**REQUEST TO CHANGE PEET FLAGSTONE PDA DEVELOPMENT APPROVAL
SECTION 99 OF ED ACT – FLAGSTONE CITY: CA3 SOUTH (EDQ REF: DEV2024/1491/3)**

It is proposed to make minor amendments to the latest approval package issued by EDQ on 16 June 2026, pursuant to Section 99 of the *Economic Development Act 2012* (the Act).

Approved Cross Section

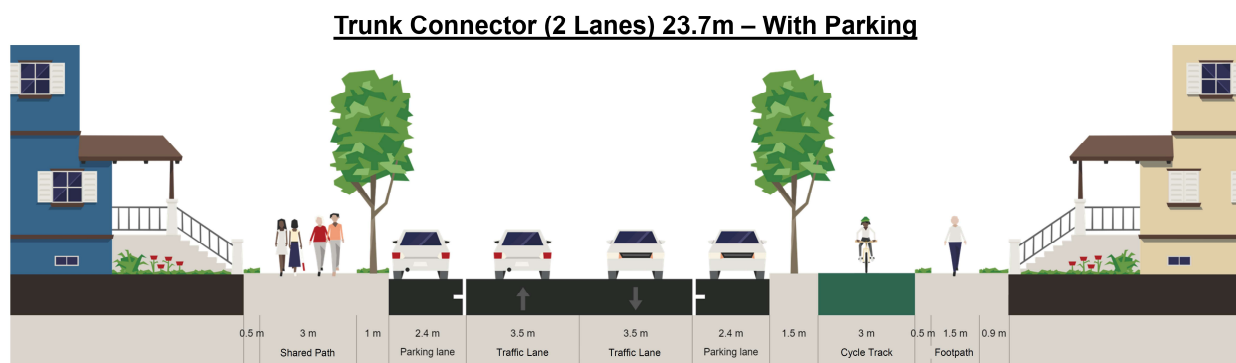
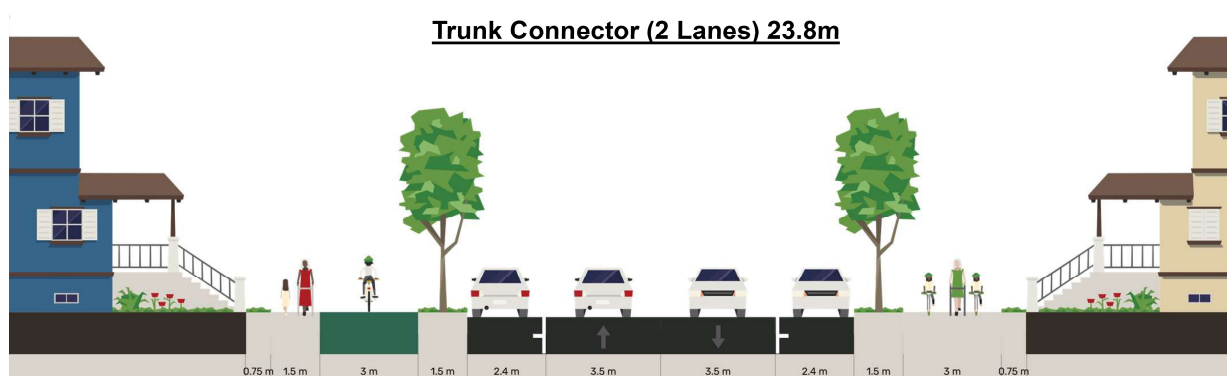
The Trunk Connector road type is proposed to increase in width from 23.7m to 23.8m for the balance of stages within CA3 South being Stages 9, 11, 13 and 14. This change matches the width extent of both Trunk Connector and Neighbourhood Connector roads in the last Change Approval to CA3 South relating to Stages 10 and 12. Linework for the road has also been updated based on progressed detailed engineering design. No changes are proposed to cycle tracks or shared paths where applicable, pedestrian footpaths, parking lanes nor traffic lane widths. The changes primarily relate to the verge treatments and is described as follows:

- Planting at front of kerb is proposed to remain 1.5m in width.
- Cycle track is proposed to remain 3m in width.
- Separation between cycle track and footpath is proposed to be removed.
- Footpath is proposed to remain 0.9m in width.
- Planting at back of kerb is proposed to be 0.75m in width.
- Overall the verge on the separated cycle track and footpath side of the road is proposed to be reduced from 7.4m to 6.75m in width.

- Planting at the front of kerb is proposed to increase to 1.5m in width from 1m.
- The shared path is proposed to remain 3m in width.
- Planting at the back of kerb is proposed to increase from 0.5m to 0.75m.
- Overall the verge on the shared path side of the road is proposed to increase from 4.5m in width to 5.25m in width.

When accounting for the lack of change to the carriageway widths, the increase in width of the shared path verge by 0.75m is partially offset by the decrease in width to the of cycle track verge of 0.65m. Overall this accounts for the increase in road width for the Trunk Connector within CA3 South. The additional 0.1m width has been subtracted from the surrounding open space and residential allotments.

Table 1: Proposed changes to Stage 9D-1

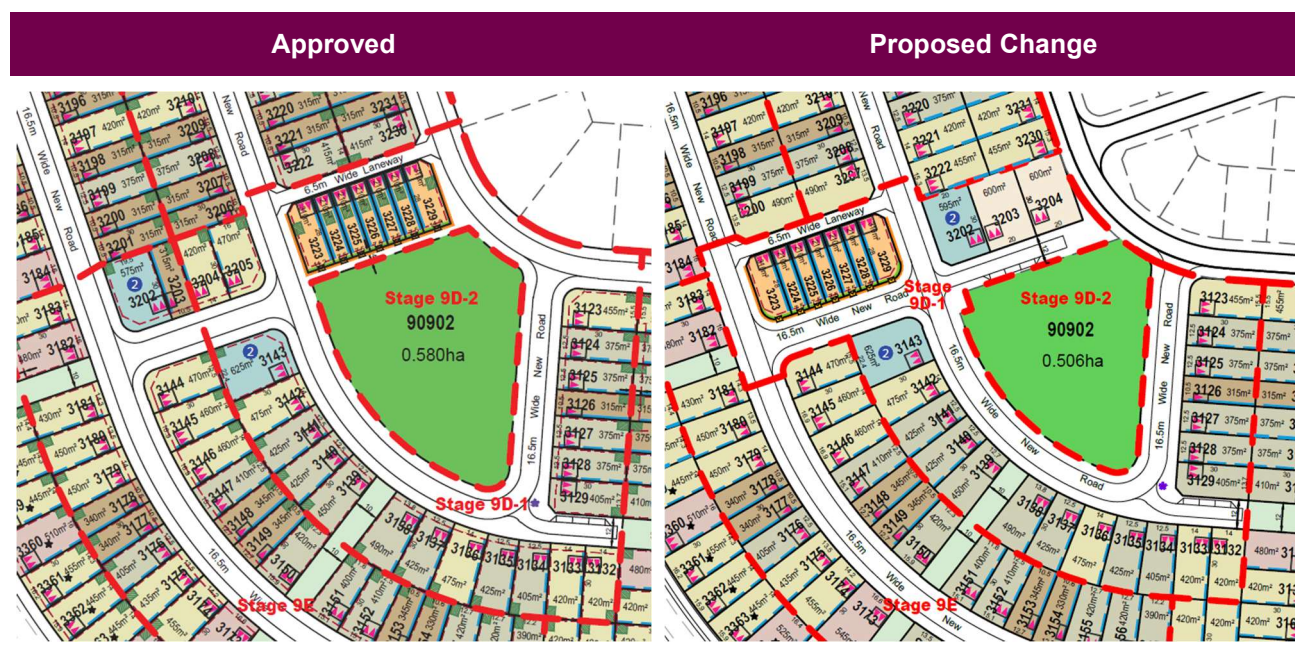
To achieve a more balanced earthworks outcome, the redesign of Stage 13 includes adjoining Stage 9. Earthworks within Stage 9 introduces a minor increase in fill to better respond to the existing landform. Under the approved layout, rear-loaded terrace lots were proposed adjacent to the Neighbourhood Recreation Park within Stage 9D-2. The revised layout relocates these terrace lots to the adjoining block immediately to the west. The changed levels for Stage 9 has resulted in the terraced lots, which are more responsive to level differences along side boundaries, being shifted west to a location that is required to have greater level difference under the revised earthworks strategy.

Refer to the proposed changes to Stages 9D-1 and 9E in **Table 1**.

Figure 1 – Wide Neighbourhood Lane (14.5m) cross-section

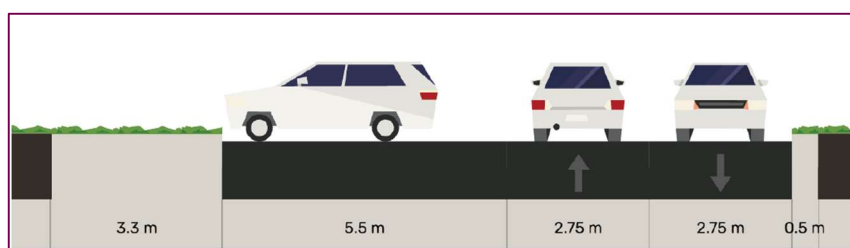
- Two (2) 20.2m wide access streets connecting to the Neighbourhood Connector (Stage 9M-1 road),
- 6.5m wide laneway access to rear-loaded terrace allotments in Stage 9M-2 with a nominal bin pad at the laneway entrance for Lots 3001 and 3002; and
- 14.5m wide laneway access to rear-loaded terrace allotments in Stage 9N, including perpendicular parking along the southern verge of the terrace blocks for visitor parking. The cross section for this road is provided in **Figure 1** below.

Figure 4 – Proposed split-level lots in Stage 13 (POD)

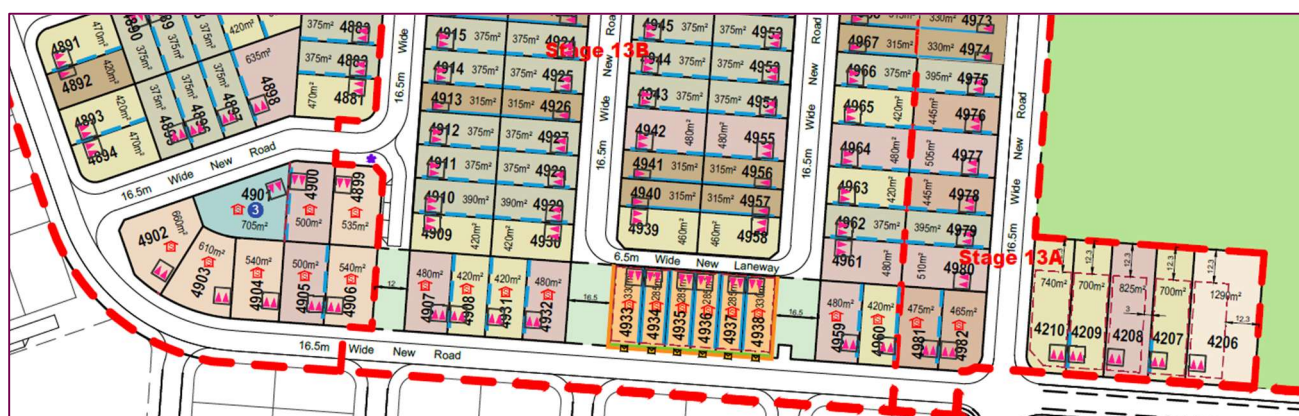
Twenty-two (22) split-level lots are proposed within the redesign area. These lots utilise built-form outcomes already demonstrated and accepted within Stages 10K and 12A-1 through the most recent change approval. The split-level lots are generally confined to the southern portion of Stage 13, where allotments run parallel to the natural slope and cannot be reorientated to better address topography. Split-level outcomes have been minimised wherever practical. While these lots attract a higher construction cost, the Applicant's revised Stage 13 development strategy can accommodate this additional cost while achieving a significantly improved overall yield and neighbourhood outcome.

Refer to the extent of split-level lots in **Figure 4**. Refer to an excerpt of the bulk earthworks plans demonstrating how split-level lots are designed from a civil perspective in **Figure 5**.

Figure 6 – Proposed changes to POD Plans (Stage 9M-2 and 9N)

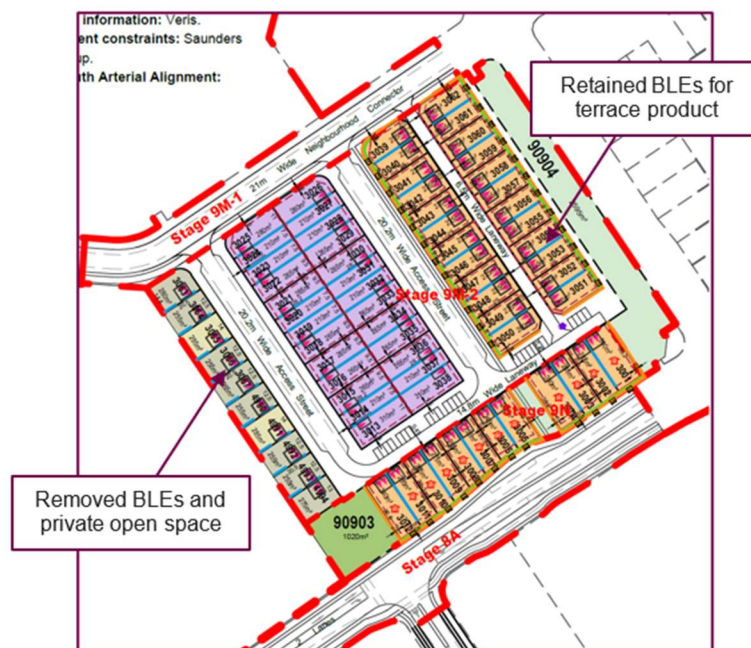
It is proposed to remove maximum building location envelopes (BLEs) and indicative private open space from the POD Plans for Stages 9 and 13. Both have previously been approved on CA3 South POD Plans.

Refer to the proposed changes to POD Plans in **Figure 6** for Stage 9M-2 and 9N, as an example. **Figure 7** provides an excerpt of the POD Lot Typology Diagrams.

Figure 7 – Proposed typical BLEs (POD Lot Typology Diagrams)

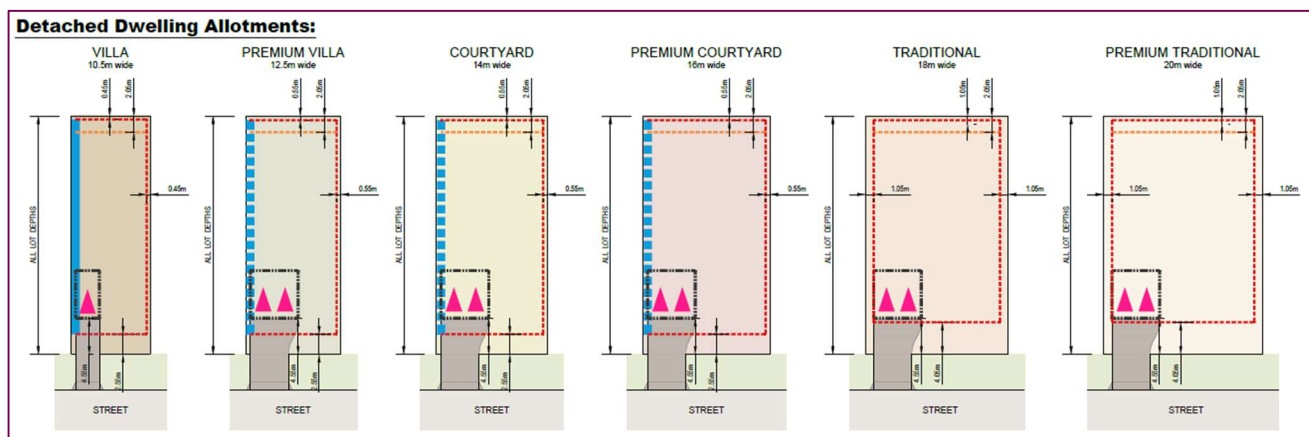
The inclusion of a BLE on each individual allotment also creates a significant amount of rework each time the layout is amended. To provide a visual representation of the setbacks for each lot type, the Applicant has opted to include a POD Lot Typology Diagrams document (one (1) page) within the POD Plans package. This page seeks to provide clarity regarding the detached dwelling allotment types (villa, premium villa, courtyard, premium courtyard, traditional and premium traditional) and their BLEs could look like on a typical pad.

These BLEs also includes an 'additional rear setback' to capture POD Notes 16 and 17, requiring are 2.05m setback to OMP when adjoining a rear retaining wall over 2.0m. The intent is to simplify the presentation of POD controls by consolidating them into a single document that applies consistently across all stages. This approach avoids the need for stage-specific variations and allows more detailed, lot-specific development controls to be addressed through subsequent delivery documents, such as Disclosure Plans and Site Plans prepared at the contract phase.

Table 4: Proposed changes to sub-staging of Stage 8

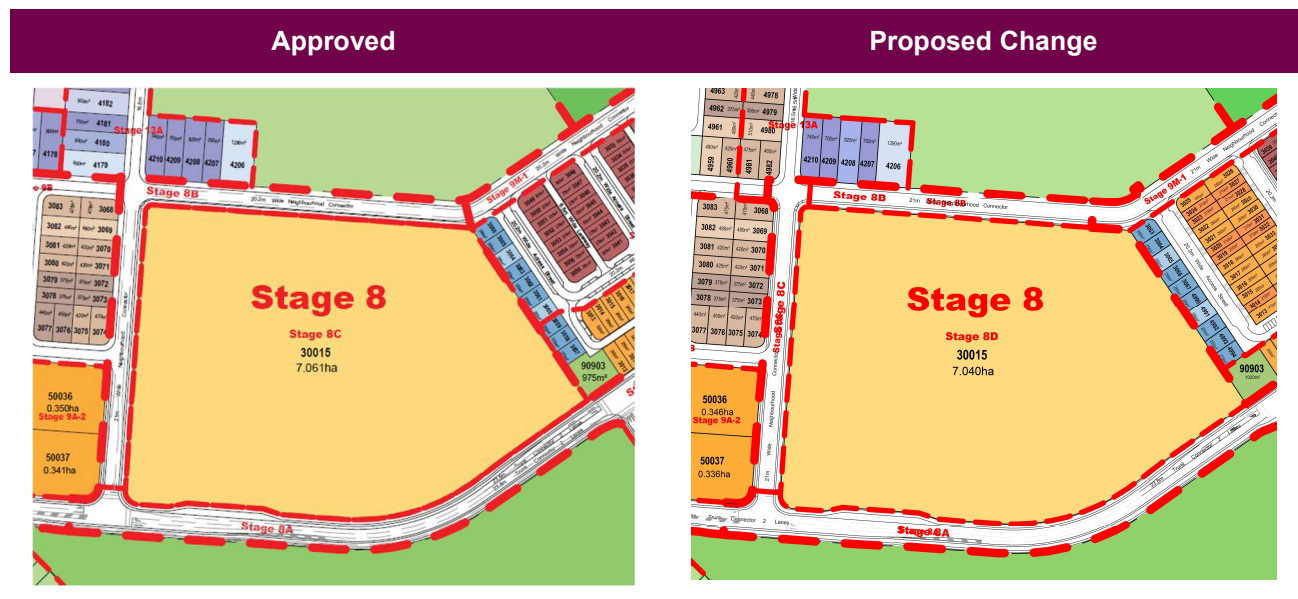
The proposed sub-staging strategy for the School RAL's change application has been reflected in the current CA3 south sub-staging extent. This involves:

- Split Stage 8B into two stages: Stage 8B for the northern Neighbourhood Connector Road, and Stage 8C for the western Neighbourhood Connector Road and associated intersection.
- School Lot 30015 has been correctively renamed as Stage 8D. Stages 8A-C incorporate the surrounding road network to the school lot as reflected in the School RAL.

Refer to the proposed changes to sub-staging in **Table 4**.

Table 5: Proposed changes to Stage 12A-1

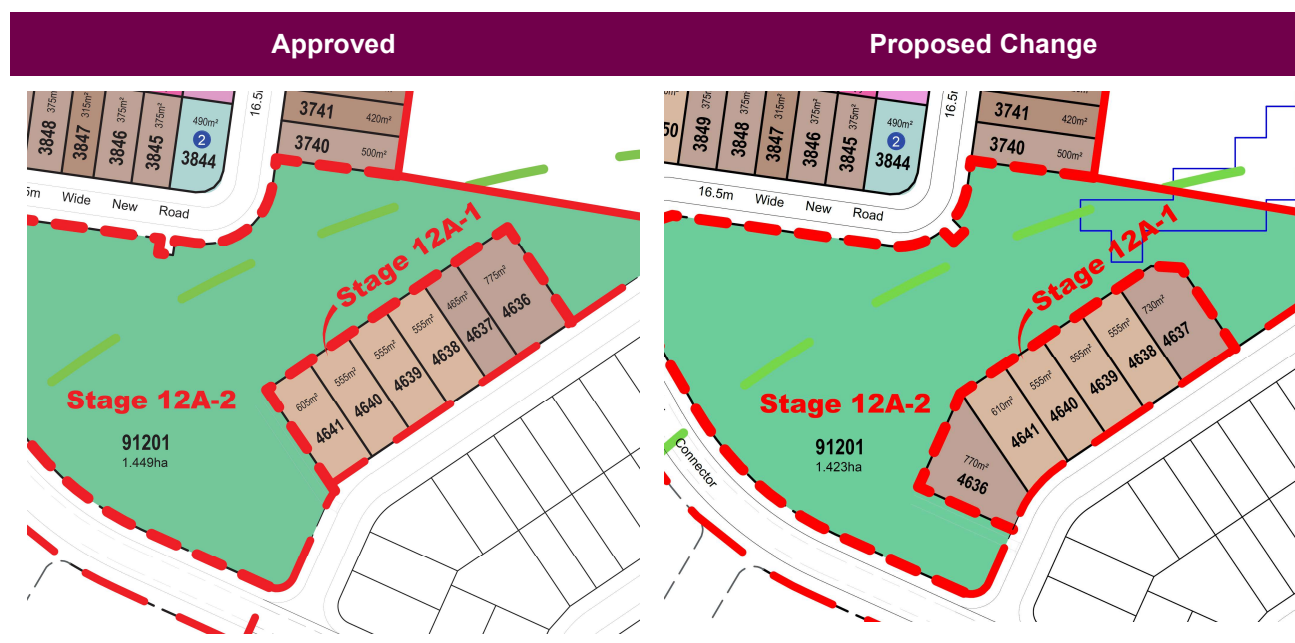
As detailed design has progressed for Stage 12, the earthworks surrounding the basin in Stage 12A-2 have caused the need for the adjoining residential lots in Stage 12A-1 to be amended. In particular, Lot 4636 at the eastern end of the row of the six (6) lots comprising Stage 12A-1 is proposed to be relocated to the western end of the block. Refer to **Table 5**.

Table 6: Proposed changes to Stage 14S

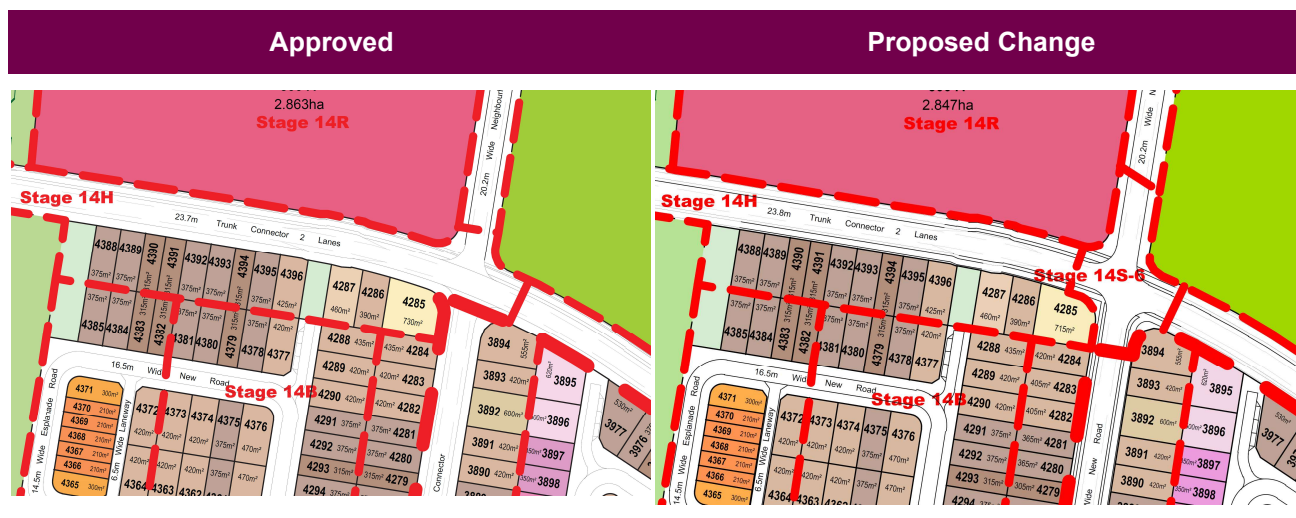
Everdell Road which is not proposed to be closed (west of Stage 14S-3), an alternative access is to be provided via the dedication of Stages 14S-1 and 14S-6 road areas to an interim standard.

It is proposed to sub-stage the intersection of the east-west Trunk Connector road and the north-south Neighbourhood Connector Road, which was previously included within Stage 14H. This is to enable flexibility in the delivery of an interim intersection, limit the extent of road opening within Stage 14 until ultimate delivery is required and limit the sub-stage to areas of road only. The new sub-stage includes road stubs in all directions to provide the greatest flexibility. The northern intersection road stub extends to the alignment of Everdell Road which is proposed to be retained to ensure connectivity with New Beith Road. Refer to **Table 6** for further details.

Table 7: Stages 11L-1 and 11L-2

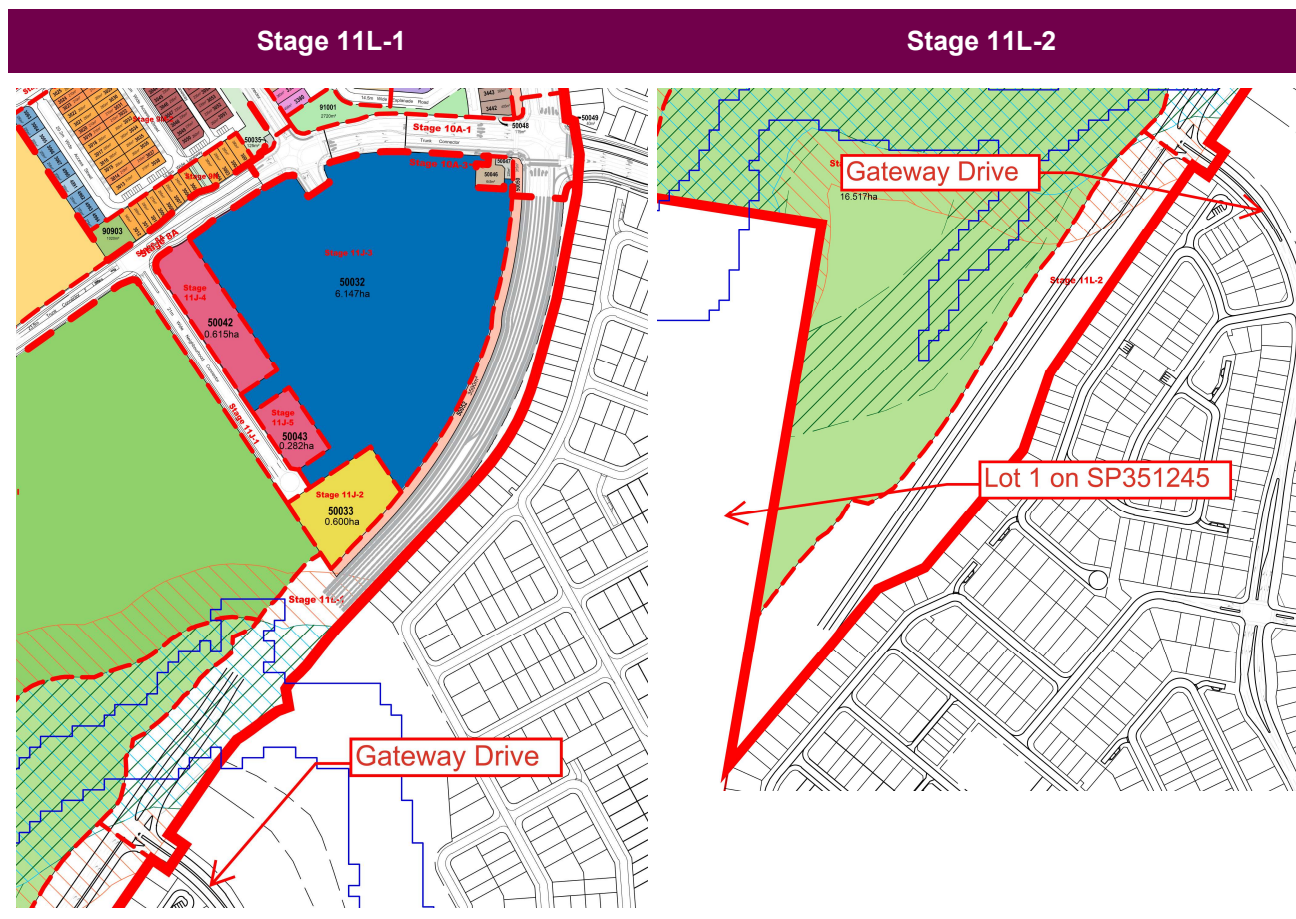
The endorsement of the 150th lot of this approval is likely to occur as part of Stage 10H which is scheduled to be submitted for endorsement (plan sealing) in August 2026. While the design for New Beith Road to up to and including the intersection with Gateway Drive has progressed, the design will not be able to be submitted for compliance assessment prior to the endorsement of the 150th lot of CA3 South.

Instead, it is proposed that the detailed design for the Stage 11L-1 section of New Beith Road be submitted to EDQ for compliance assessment prior to the endorsement of the 250th lot of CA3 South. There is no known reason for the 150th lot timing trigger associated with the compliance assessment as the construction/delivery

timeframe for the road is tied to the commencement of use of Lot 50033 (ambulance site) or 30015 (Stage 8 School), whichever occurs first. Neither of these allotments are scheduled for delivery in the next 1-2 years, therefore it is proposed to change the timing for detailed design compliance assessment for this section of road to a more appropriate timeframe of prior to the endorsement of the 250th lot of CA3 South.
